PG-FP4

Operating Precautions

Operating Precautions for PG-FP4

This document describes added/changed specifications, restrictions and cautions for the PG-FP4. Also refer to the user's manual of the PG-FP4 for cautions on using the PG-FP4.

No. 1 IIC communication

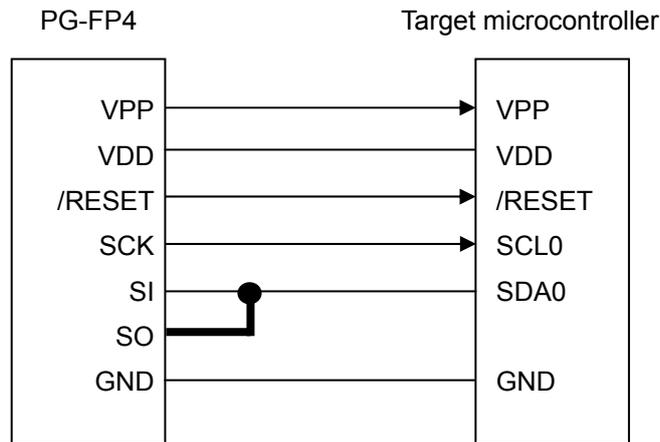
The IIC communication mode adapter board is included.

When using IIC communication mode with PG-FP4 control code B, short the SI and SO pins in the PG-FP4.

The IIC communication mode adapter board is included in products with control code C (firmware: V1.17, GUI: V2.00) and later. Use the IIC communication mode adapter board for IIC communication.

No. 32 Modification of percentage display when a verify error occurs in block mode with single-power-supply flash memory microcontroller

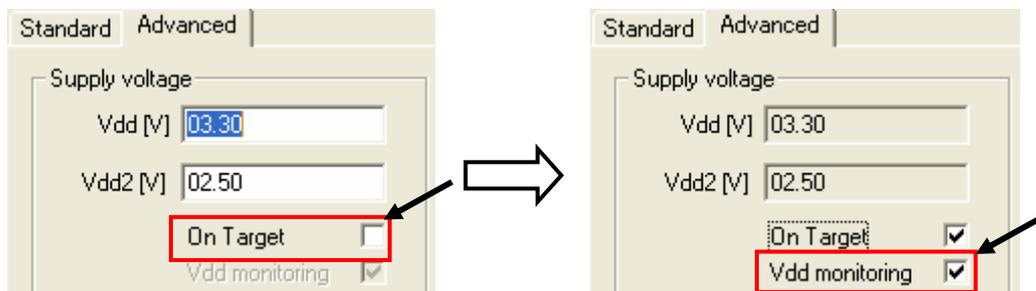
When a verify error occurs in block mode with single-power-supply flash memory microcontroller, the final display percentage does not reach 100% depending on the device used. The specification has been modified so that a percentage indication of up to 100% is displayed.

This issue has been implemented in products with control code G (firmware: V1.33, GUI: V2.15) and later.

Figure 2-6. Connection Diagram

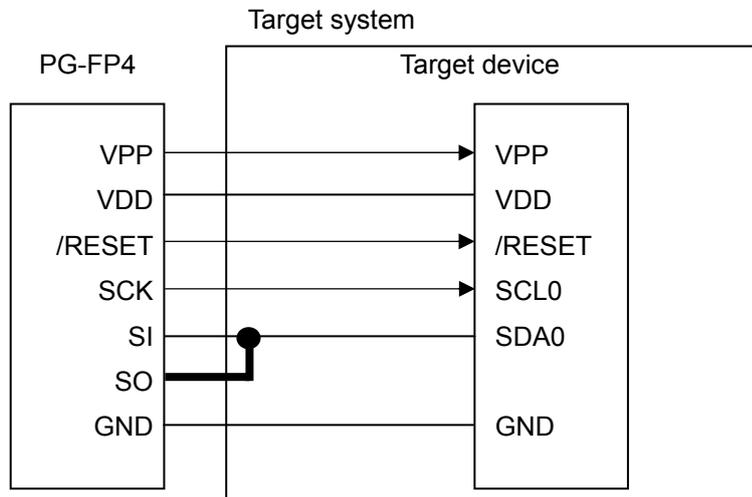
The adapter board for IIC communication mode that is included with the PG-FP4 has been changed to the IIC/78K0S/KX1+ adapter in control code G and later. In conjunction with this change, replace the following descriptions with section 2.3.9.

When I²C communication mode is used and the IIC/78K0S/KX1+ adapter is not used, short the SI pin and SO pin in the target system.

Figure 2-7. Connection Diagram When Using IIC/78K0S/KX1+ Adapter

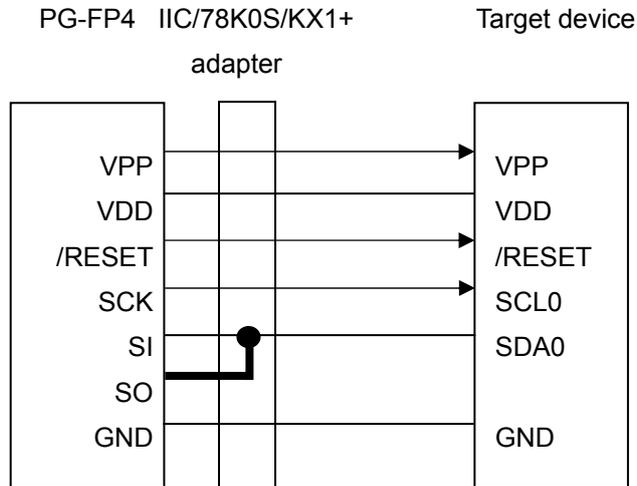
When I²C communication mode is used and the IIC/78K0S/KX1+ adapter is used, shorting the SI pin and SO pin in the target system is not required.

Figure 2-8. Connection Diagram When Using IIC/78K0S/KX1+ Adapter

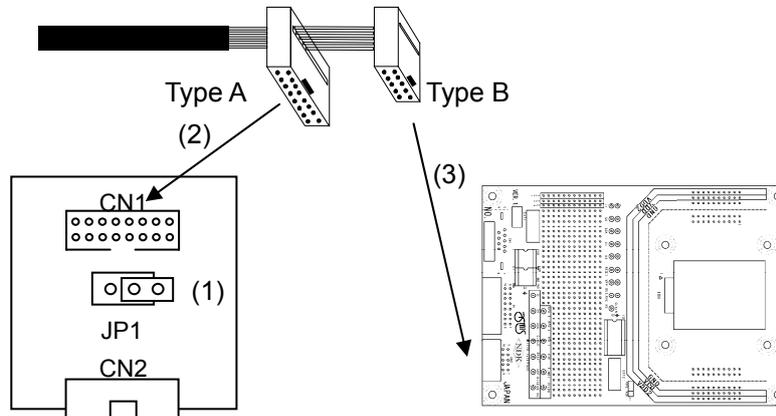
- (1) Leave JP1 open.
- (2) Connect the program adapter and target connector type B (10 pins) of the target cable.
- (3) Connect target connector type A (16 pins) of the target cable and the IIC/78K0S/KX1+ adapter (CN1).

Figure 2-9. Connection Diagram When Using IIC/78K0S/KX1+ Adapter

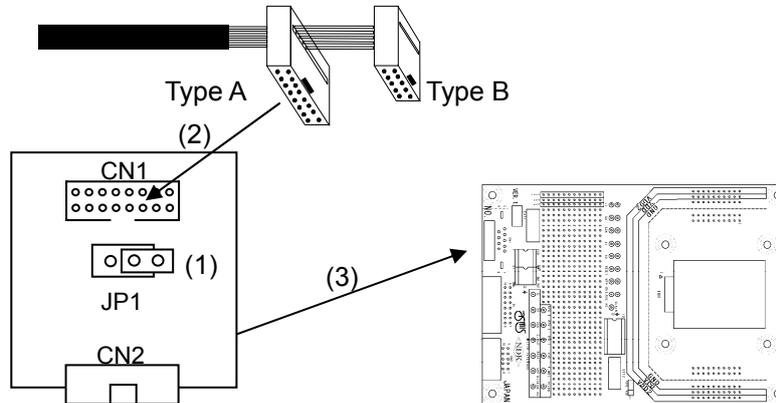
- (1) Leave JP1 open.
- (2) Connect target connector type A (16 pins) of the target cable and the IIC/78K0S/KX1+ adapter (CN1).
- (3) Connect the program adapter and the IIC/78K0S/KX1+ adapter (CN2).

Figure 2-10. Connection Diagram

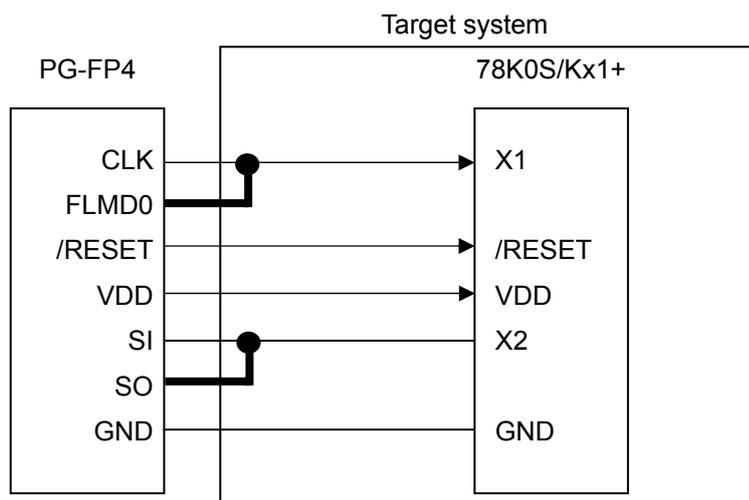
When the 78K0S/KX1+ is used and the IIC/78K0S/KX1+ adapter is not used, short the SI pin and SO pin, as well as the CLK pin and FLMD0 pin in the target system.

Figure 2-11. Connection Diagram When Using IIC/78K0S/KX1+ Adapter

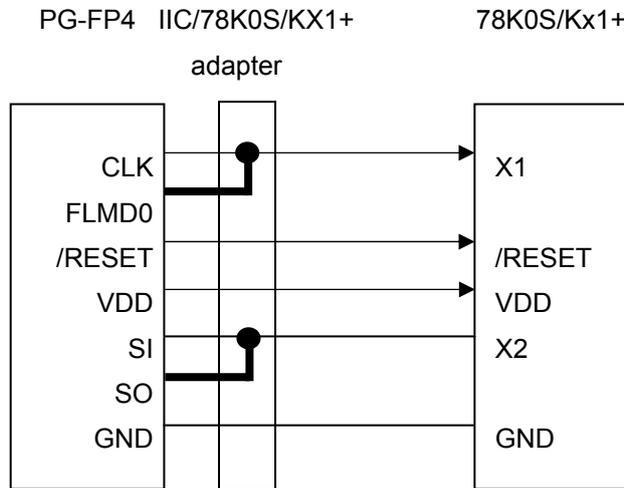
When the 78K0S/Kx1+ is used and the IIC/78K0S/KX1+ adapter is used, shorting the SI pin and SO pin, as well as CLK pin and FLMD0 pin in the target system is not required.

Figure 2-12. Connection Diagram When Using IIC/78K0S/KX1+ Adapter

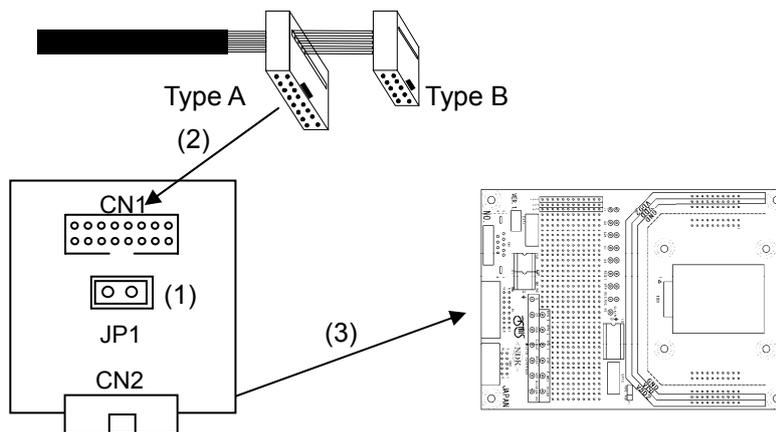
- (1) Short JP1.
- (2) Connect the target connector type A (16 pins) of the target cable and IIC/78K0S/KX1+ adapter (CN1).
- (3) Connect the FA adapter with the IIC/78K0S/KX1+ adapter (CN2).

(3) [Checksum] menu specifications

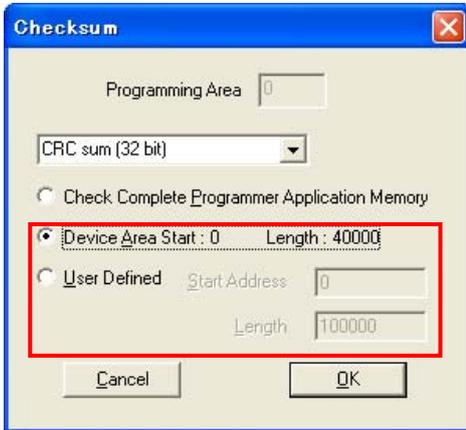
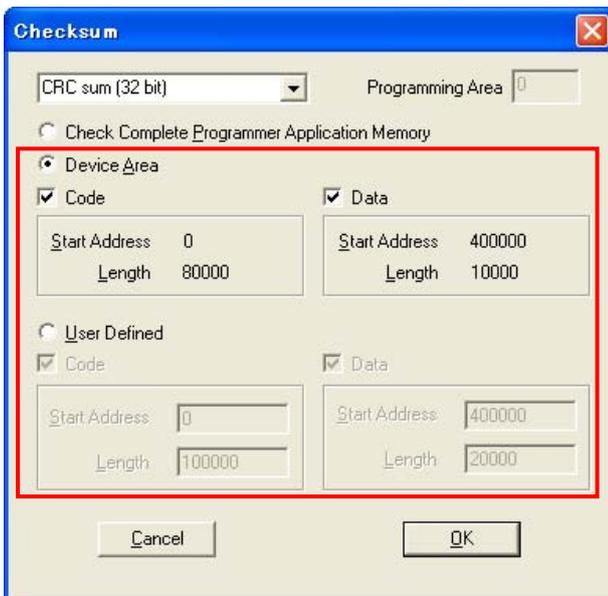
When [Checksum] in the [File] menu is executed, the window display varies depending on whether or not the downloaded parameter file supports the data flash area.

After clicking the OK button, the following information will be displayed in the File Checksum area of the programmer parameter window.

After clicking the OK button, the following information will be displayed in the File Checksum area of the programmer parameter window.

(4) [HEX Editor] menu specifications

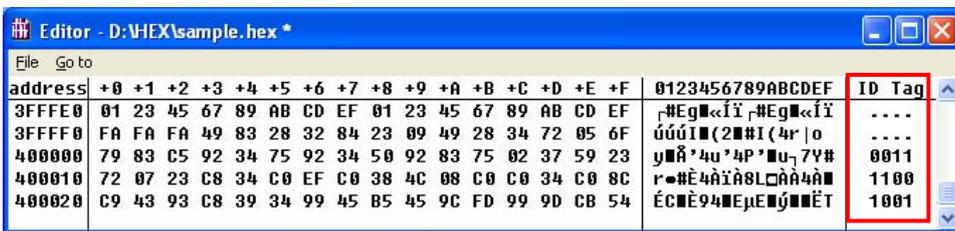
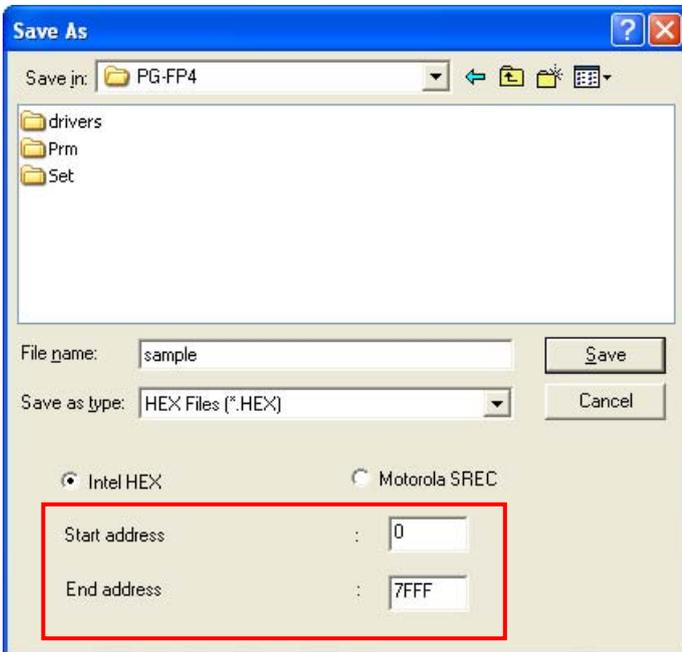
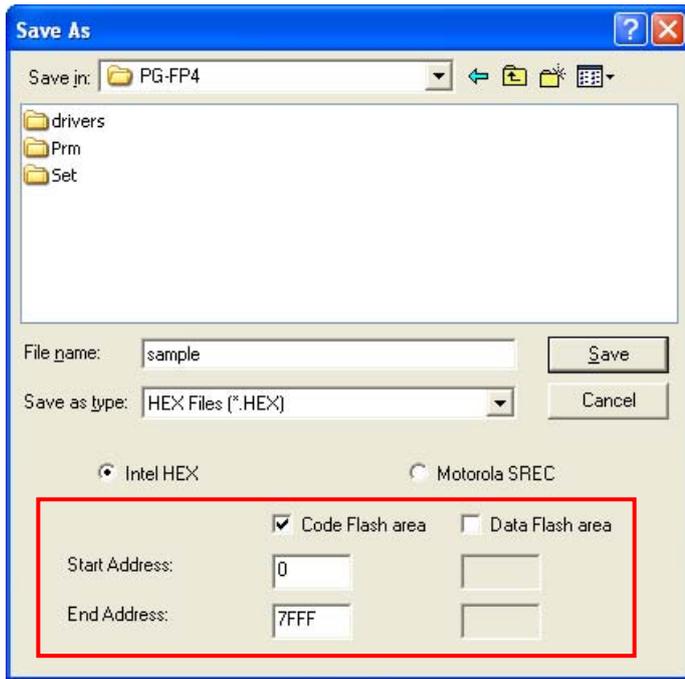
An ID Tag row has been added to the [HEX Editor] in the [File] menu. The ID Tag row is used in microcontrollers that support the data flash area. Only the values at addresses 400000h and beyond can be edited in the ID Tag row.

When a parameter file is downloaded using the [HEX Editor] and the file is saved as, the available options in the [Save As] window vary depending on whether or not the downloaded file supports the data flash area.

(5) Specifications for Standard tab in Device Setup window

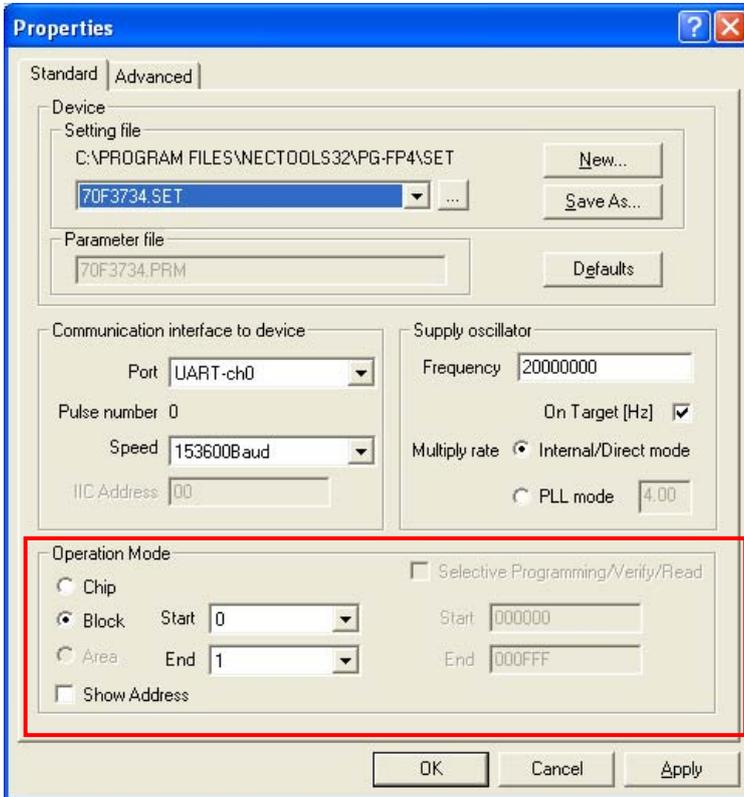
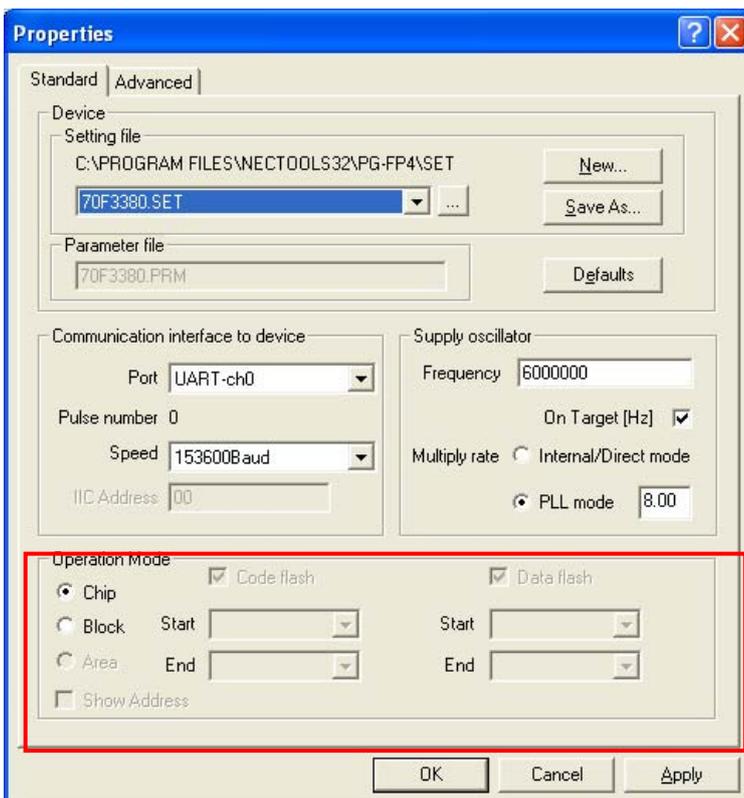
The available options on the Standard tab in the Device Setup window vary depending on whether or not the downloaded file supports the data flash area.

(6) [Upload from FP4] menu specifications

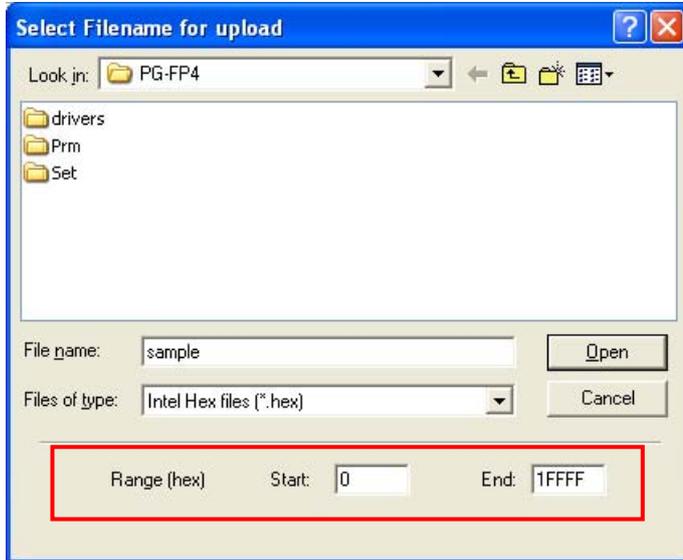
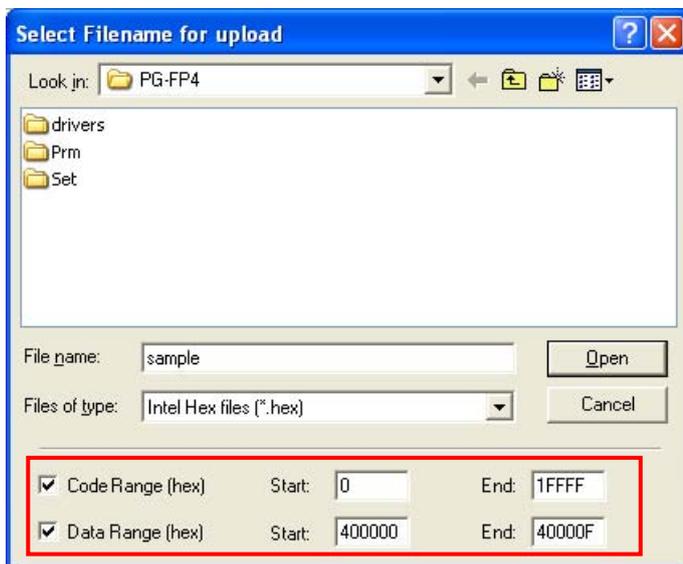
The available options in the “Select Filename for upload” window vary depending on whether or not the downloaded file supports the data flash area.

Caution Specify twice the required for the data range in order to accommodate the ID tag data.

Layout of Advanced tab in Device Setup window

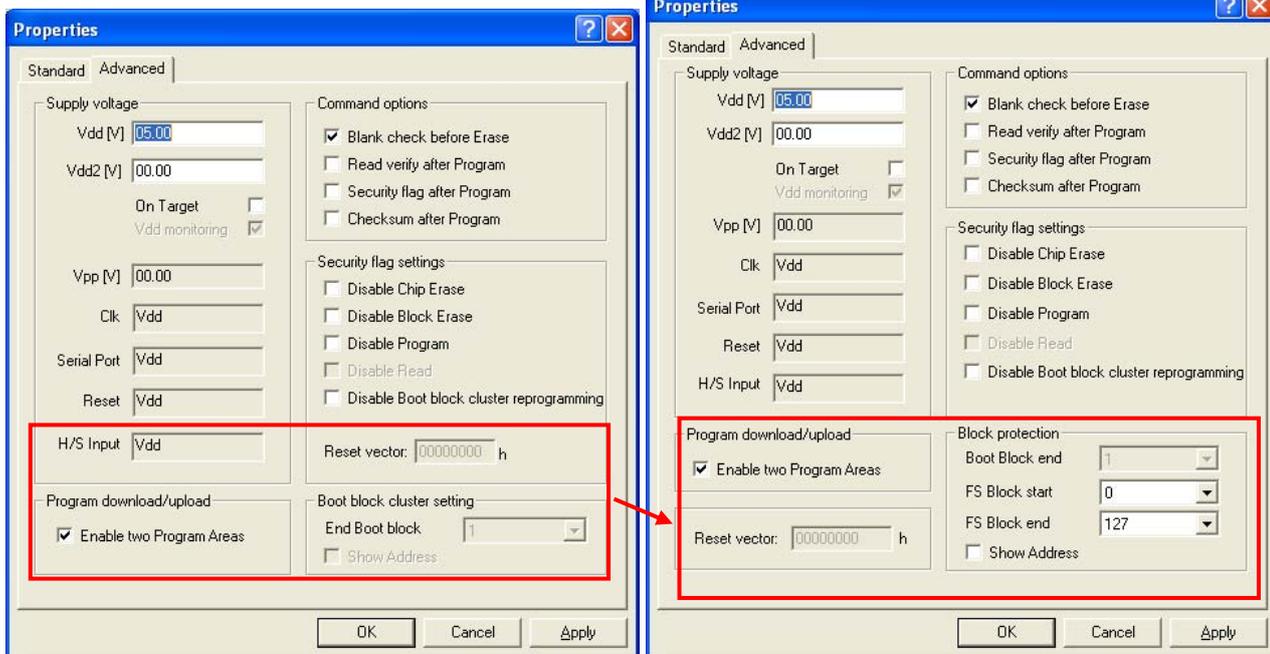
The 78K0R microcontrollers are supported in products with control code H (firmware: V1.36, GUI: V2.17) and later. In conjunction with this addition, the following boot block settings have been added.

Figure 7-5. Host Cable Connections

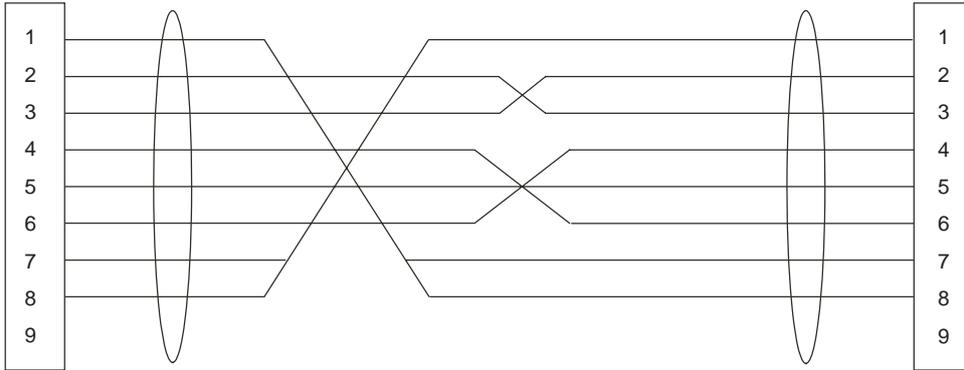
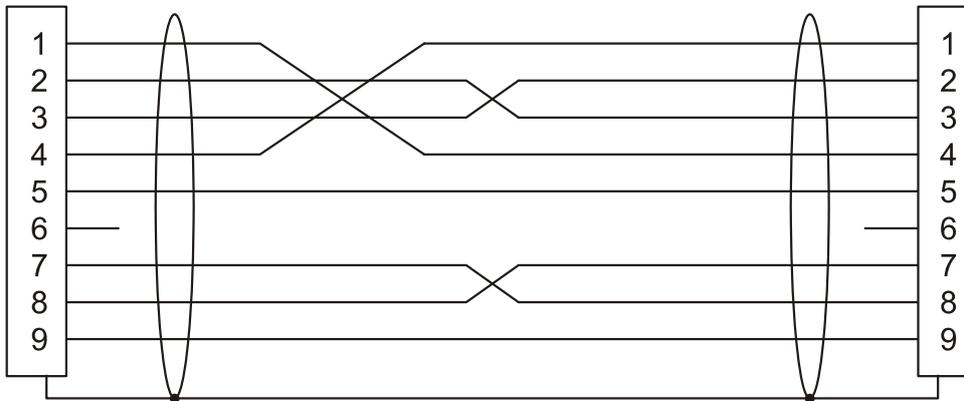
Incorrect:

Correct:
